# Bid Addendum

## Addendum No.: 3

Project Name: Harnett Street Stormwater Improvements

1. Requests for Information
  - a. See attached document
2. Changes to the Project Manual
  - a. Bid form
3. Changes to the Construction Documents
  - a. C51, C52, C53, C54

C53

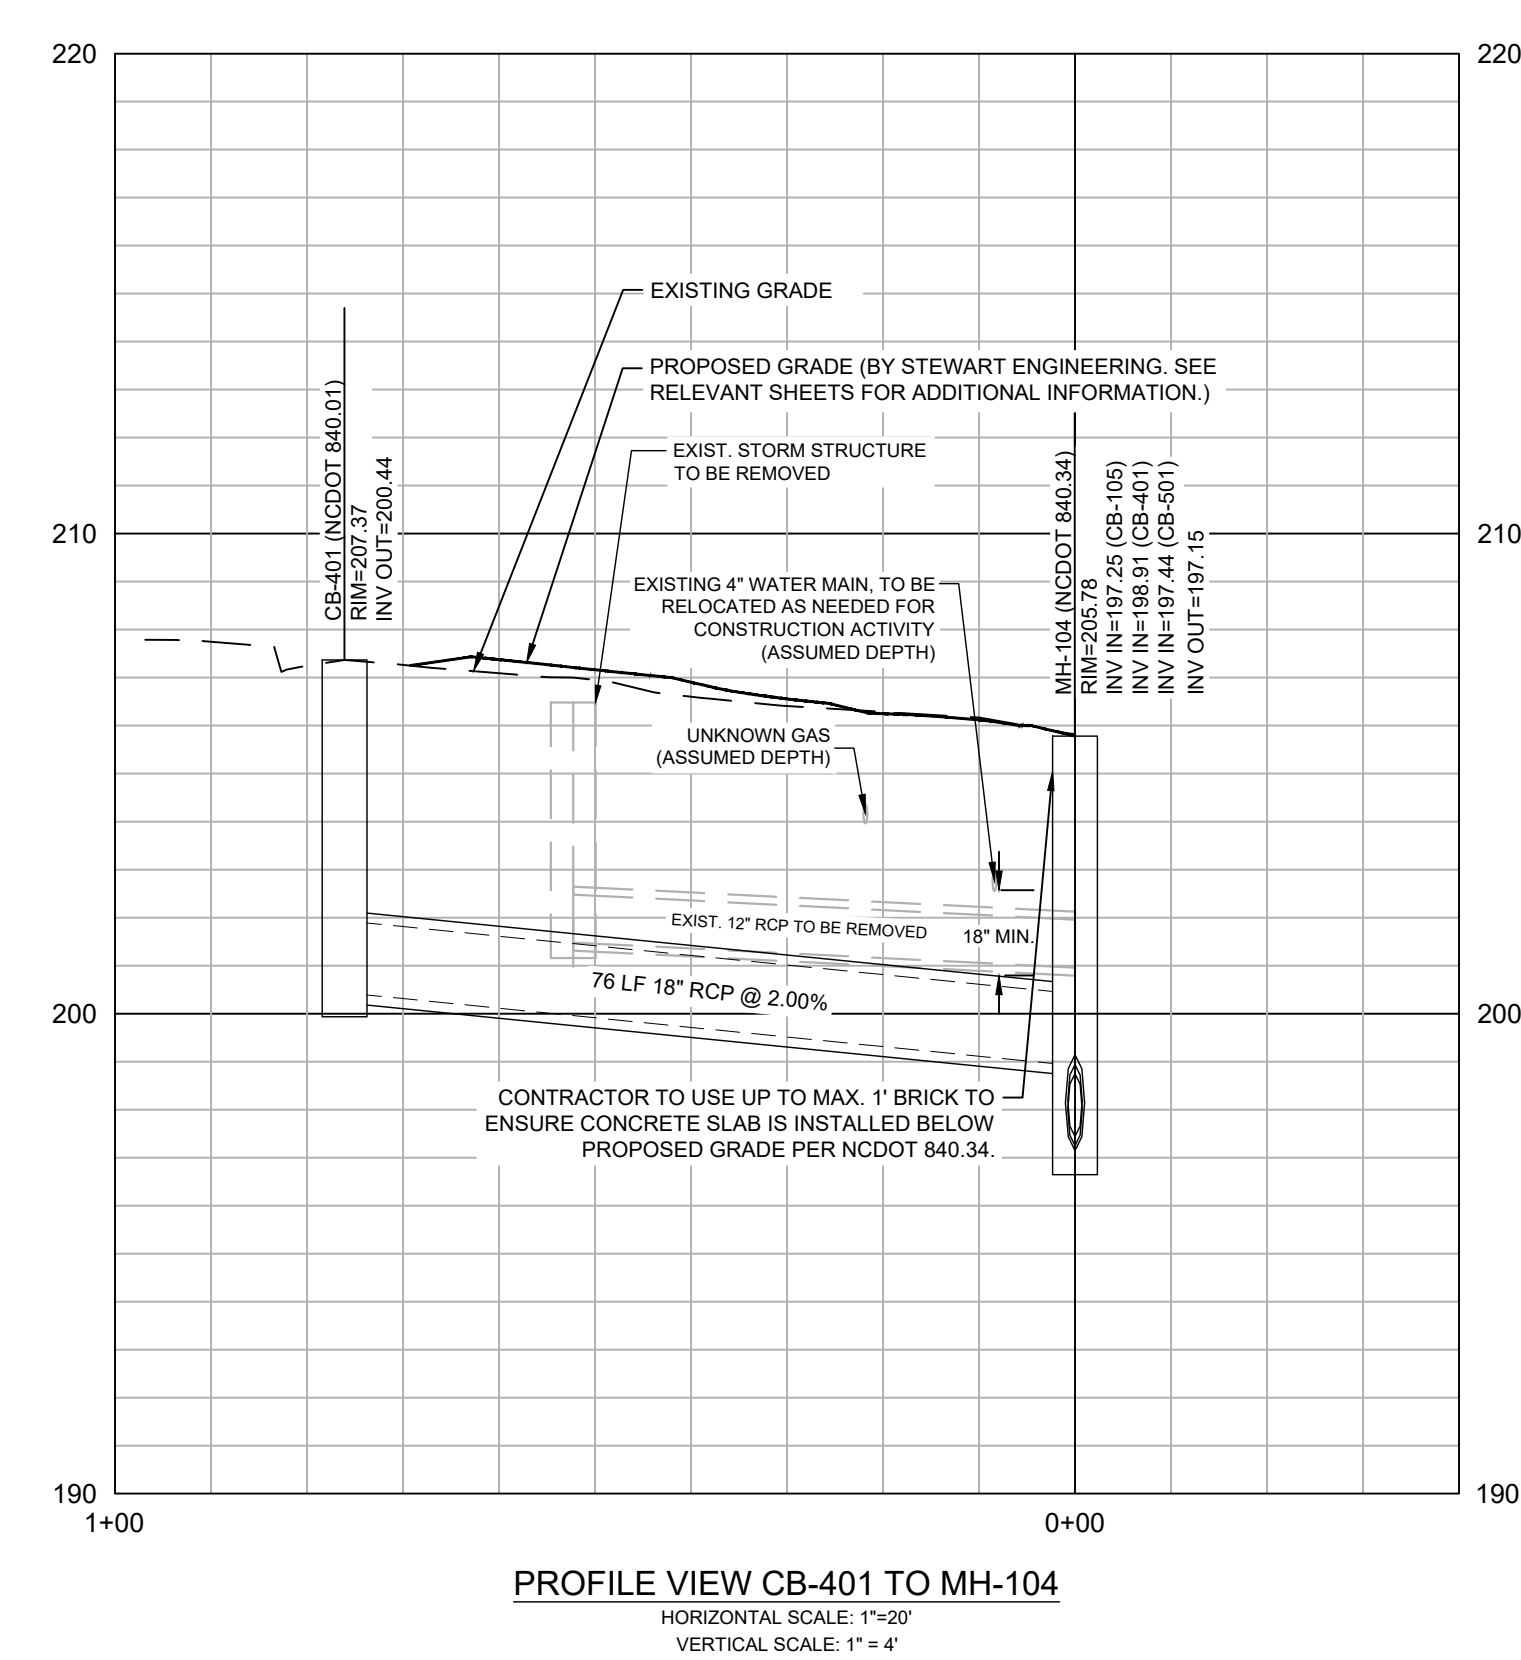
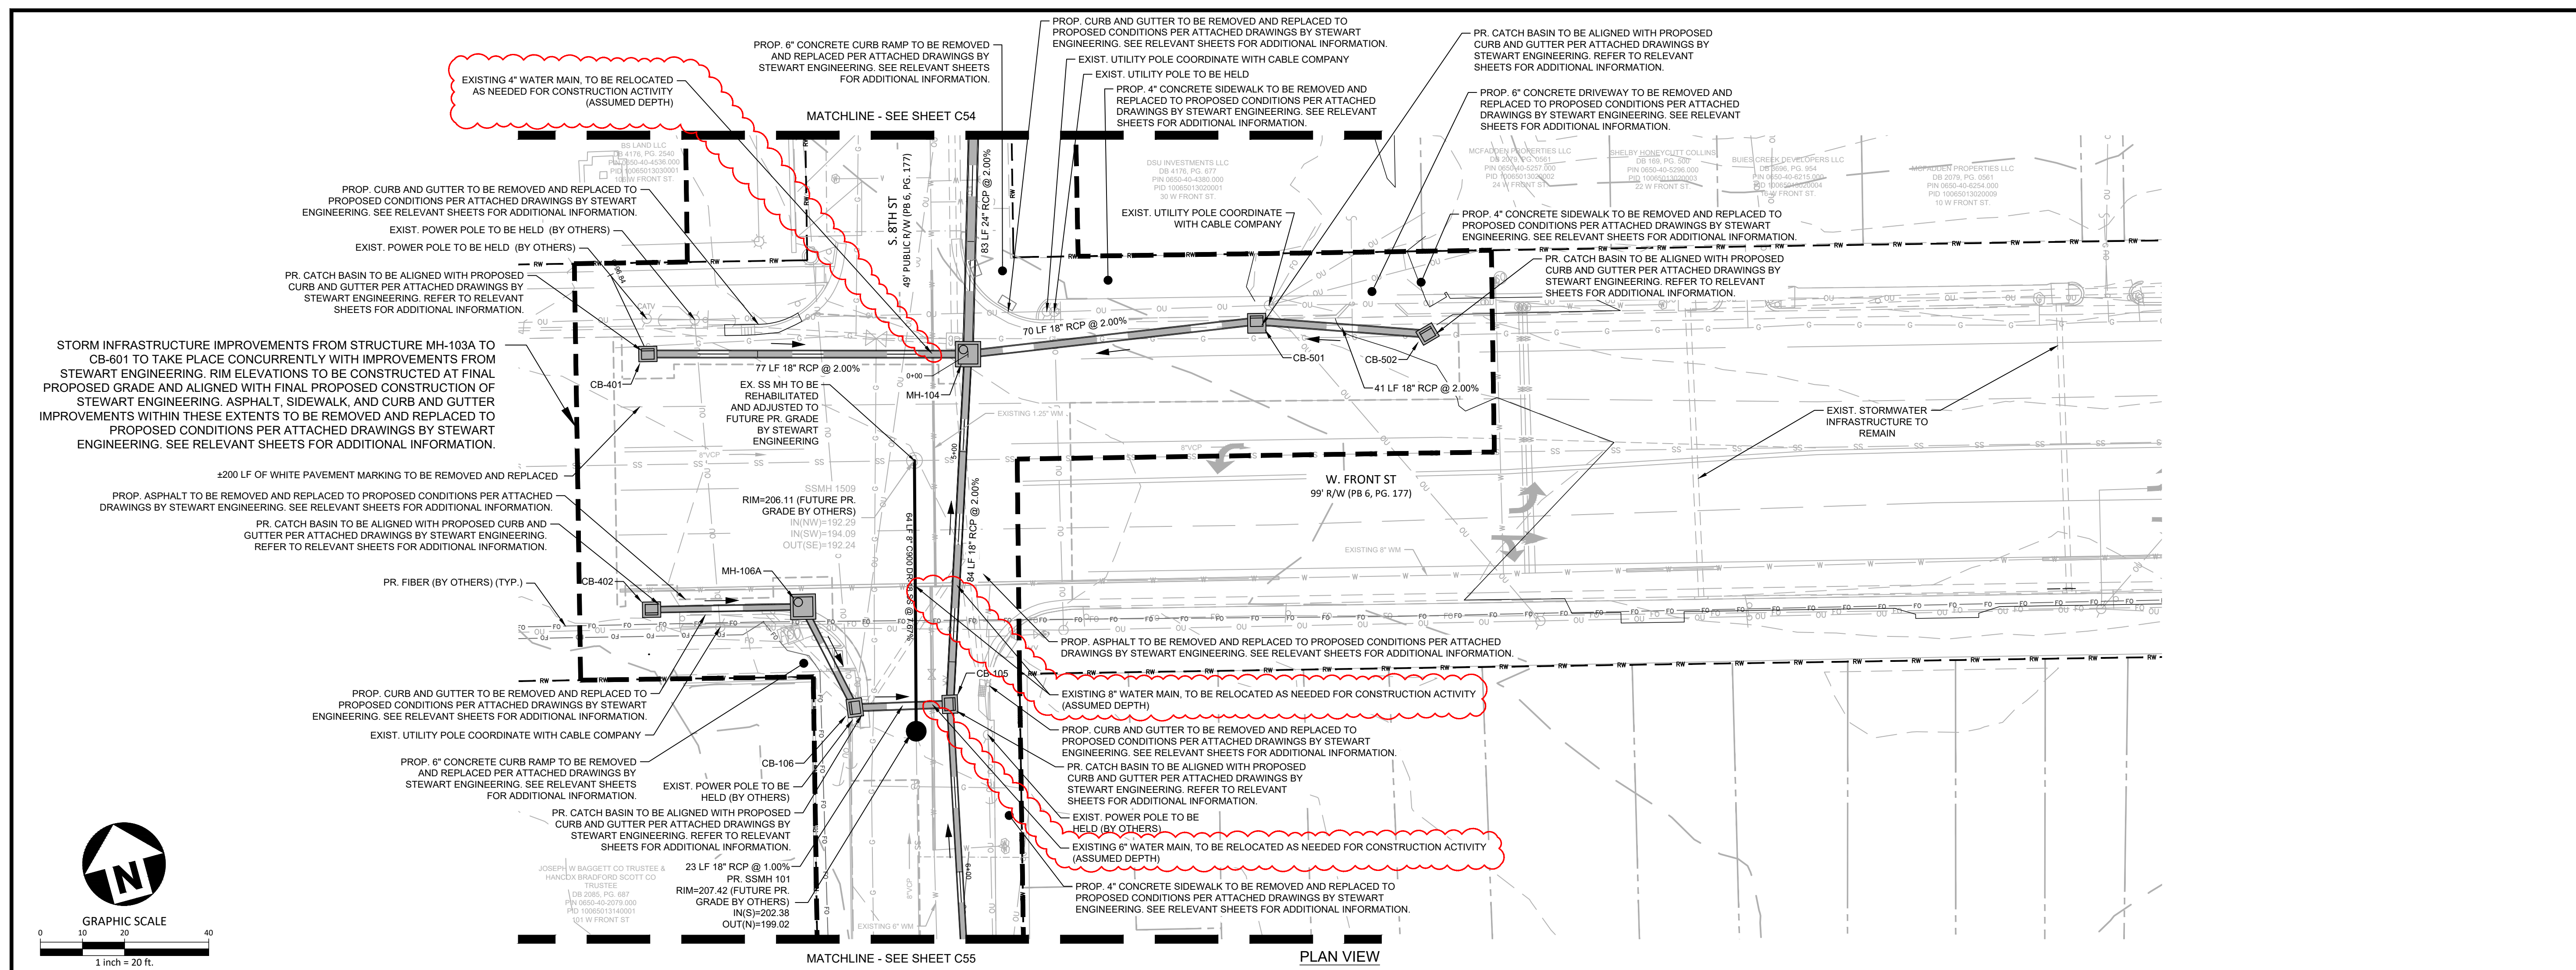
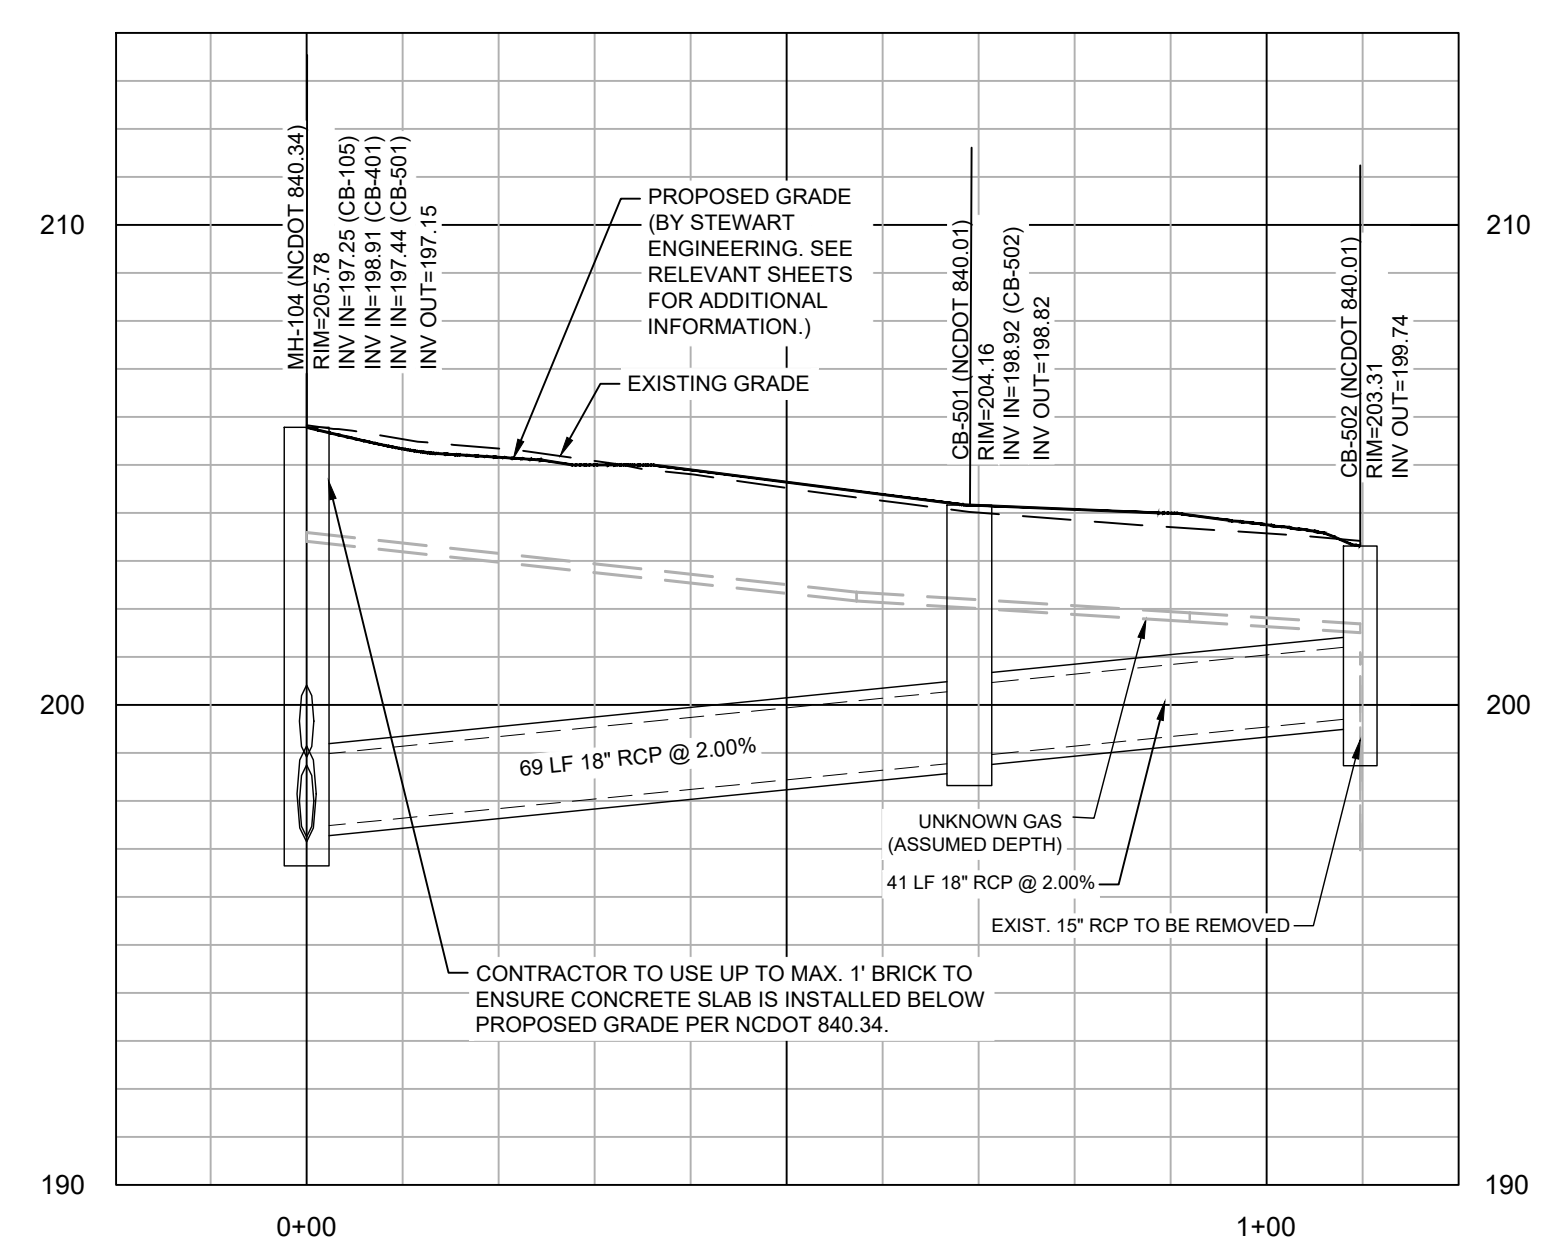
8. Are there waterline plans that correspond to the waterline bid items on the McAdams bid form? Only 6" Waterline relocations are shown on the plans.

**Engineer Response: There are 6" waterlines that are being relocated horizontally, shown in plan view in the construction documents (Sheets C51, C52, C54). There are also vertical relocations due to unknown watermain depths, which account for the additional 4" and 8" waterline bid items (A-41, A-43). These horizontal and vertical relocations are reflected in profile view in the construction documents (see attached Sheets C51, C52, C53, C54).**
